# UNITED STATES PATENT AND TRADEMARK OFFICE

APPLICATION NO.	FILING DATE	FIRST NAMED INVENTOR	ATTORNEY DOCKET NO.	CONFIRMATION NO.
09/923,288	08/06/2001	Hubert T. McGovern	OMG/129/US	9047

# Office Action Summary

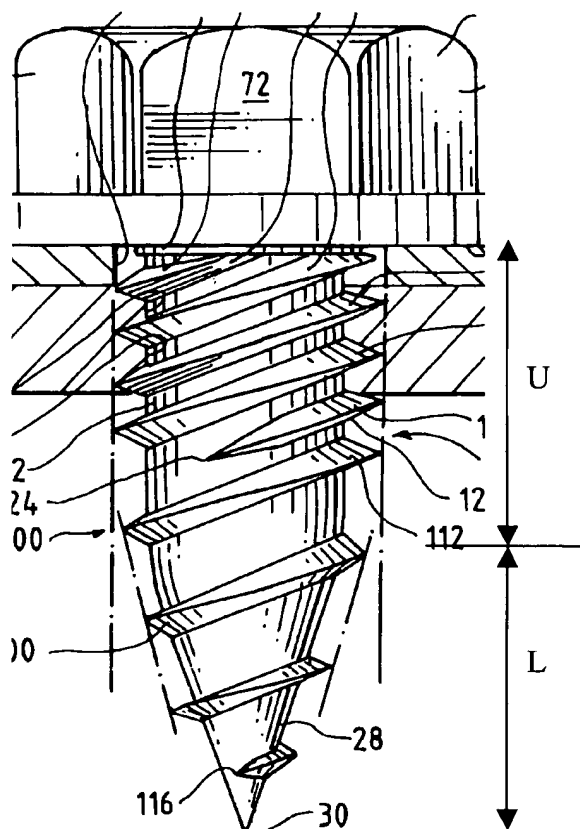
Regarding the claims, Hsing discloses a screw shaft and head, the head provided with a top surface 72 being able to receive a tool, the shaft provided with a threaded upper region 120, which refers to the entire upper region of the shaft (also labeled as U on the Figure below), located proximate the head and a threaded lower region 100, which refers to the entire lower region of the shaft (also labeled as L on the Figure below), near a distal end of the screw, the distal end having a tip 30, the cross sectional area of the shaft in the upper region being greater than that of the shaft in the lower region, and the

number of threads per unit length in the upper region being at least twice the number of threads per unit length in the lower region. Hsing further discloses the thread pattern of the lower region being symmetrical.

15. Applicant argues that Hsing fails to disclose "a shaft with a cross sectional area in the upper region greater than the cross sectional area of the shaft in the lower region". The examiner respectfully disagrees. Although Hsing discloses shank 22 being "generally cylindrical", this is only referring to the upper region of the shank. Both the cylindrical portion 22 (also labeled as U on the figure above) and lower tapered portion 28 (also labeled as L on the Figure above) are considered to make up the entire shank of the screw. This lower tapered region 28 (or L) clearly has a smaller cross sectional area at any given point than the cross sectional area of upper region 22 (or U) and therefore reads on the claimed screw. The rejection is therefore deemed proper and is maintained.
